SUBJECT: Loess Hills Sanitary Landfill - 65-

Re: HMSP and Gas Monitoring Plan Update/Response

Loess Hills Regional Sanitary Landfill

Permit No. 65-SDP-01-72P

Existing and Proposed Hydrologic Monitoring System Plan

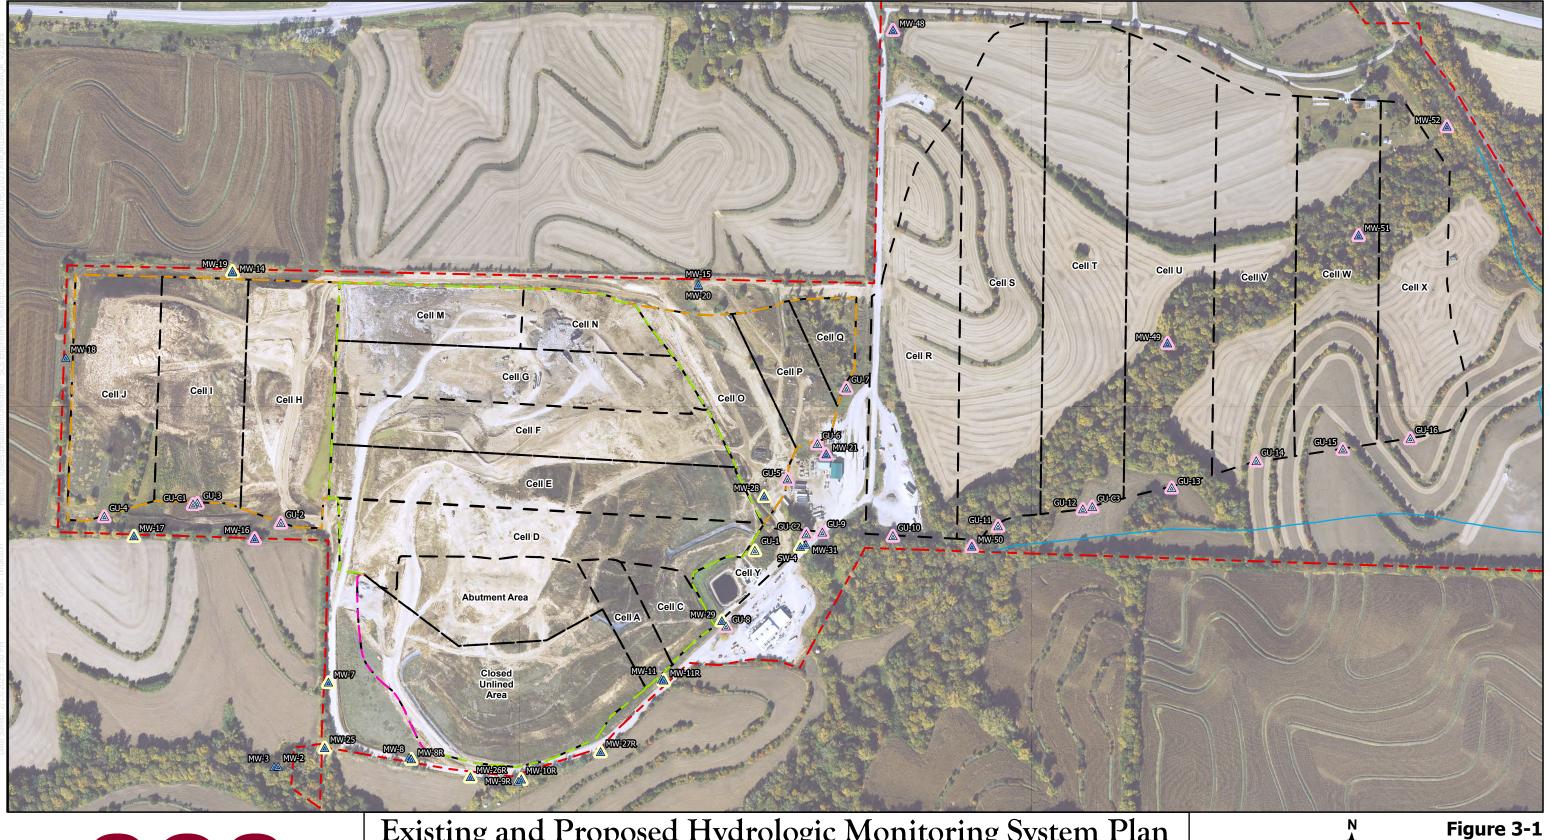
- 1. Remove monitoring points GU-2, GU-3, and GU-4.
- 2. Add existing monitoring well MW-16.

The above changes are reflected in updated HMSP Tables 3-1 (Revised) and 3-2 (Revised) included in Attachment A. Additionally, the monitoring programs of the existing HMSP monitoring points have been updated to reflect the current program as of January 2025. Figure 3-1 (Revised) in Attachment B shows the existing and proposed HMSP monitoring network with the above changes incorporated.
